802.3dj D1.0
Comment Resolution - Electrical track
Adee Ran, Cisco

Introduction

- This slide package was assembled by the 802.3dj electrical editorial team to provide background and detailed resolutions to aid in comment resolution.
- Acknowledgement to Howard Heck, Adam Healey, Chris Diminico, Mike Dudek, Matt Brown, and Kent Lusted for reviewing and contributing to this work.
- Text in red indicates editors' explanation of the comments. Italics indicate an editor's observation which might be subjective.
- The responses to the comments may point to the slides for reference but the comment report is the official record.

Figure 176E-2—Components of a 200 Gb/s per lane AUI-C2M interface and insertion loss budget at 53.125 GHz

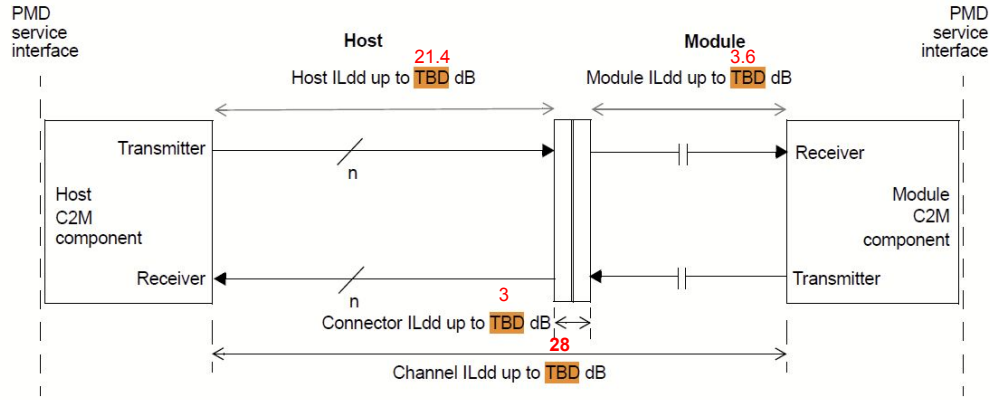
CI 176E SC 176E.2 P615 L33 # 130
 Ghiasi, Ali Ghiasi Quantum/Marvell
 Comment Type T Comment Status X
 Loss budgets are TBD
 SuggestedRemedy
 See Ghiasi C2M May-24 Contribution for background on the numbers
 IID=28 dB
 Connector with one via = 3 dB
 Module Ildd = 3.6 dB
 Host Ildd=21.4 dB
 Proposed Response Response Status O

CI 176E SC 176E.4.1 P632 L6 # 73
 Lusted, Kent Intel Corporation
 Comment Type TR Comment Status X
 The IL_dd for AUI C2M channel is a TBD
 SuggestedRemedy
 Set IL_dd = 33 per https://www.ieee802.org/3/dj/public/24_01/lusted_3dj_03_2401.pdf
 Proposed Response Response Status O

The referenced presentation is https://www.ieee802.org/3/dj/public/24_01/lusted_3dj_03_2401.pdf. The comment is against 176E.4.1 (Recommended channel characteristics/Insertion loss), which has an equation for the ILdd limit. The suggested remedy does not address the equation. The proposed Channel ILdd value is 33 dB.
